Access Compliance Report Public Rights-of-Way (Curb Ramps)

Main Street: STEARNS_AVE Cross Street: S_ESPLANADE_ST Location: NW

ADA ID: RPRK220127141653 Ramp Type: Type 4 - Parallel Initial Pass/Fail: Fail Overall Compliance: No Severity Score: 32

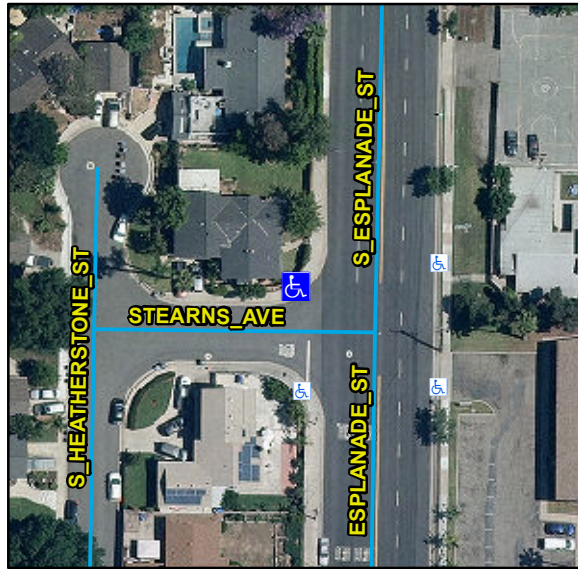
R304.5.3, R304.3.2, STD 1115

Compliance	Description	Data	Compliance	Description	Data
N/A	Ramp Length LT (in)	93	N/A	Ramp Length RT (in)	130
Yes	Ramp Width LT (in)	51	Yes	Ramp Width RT (in)	51
Yes	Ramp Run Slope LT (%)	4.7	No	Ramp Run Slope RT (%)	16.8
No	Ramp Cross Slope LT (%)	3.3	No	Ramp Cross Slope RT (%)	2.4
N/A	Landing Present	N/A	N/A	DWS Provided	N/A
N/A	Landing Length (in)	N/A	N/A	DWS Contrast	N/A
N/A	Landing Width (in)	N/A	N/A	DWS Length (in)	N/A
N/A	Landing Run Slope (%)	N/A	N/A	DWS Full Width	N/A
N/A	Landing Cross Slope (%)	N/A		DWS Offset Type	N/A
N/A	Landing Movement Obstructed?	N/A	N/A	DWS Offset Left (in)	N/A
	Landing Movement Type	N/A	N/A	DWS Offset Right (in)	N/A
N/A	Landing Shared	N/A			
N/A	Clear Space	Yes			
N/A	Clear Space To Crosswalk (in)	N/A			
N/A	Marked Crosswalk 1	No	N/A	Marked Crosswalk 2	No
	Crossing 1 Direction	S		Crossing 2 Direction	E
	Marked Crosswalk 1 Width (in)	N/A		Marked Crosswalk 2 Width (in)	N/A

Remove & Replace Curb Ramp With Two New Directional Ramps or Equivalent.
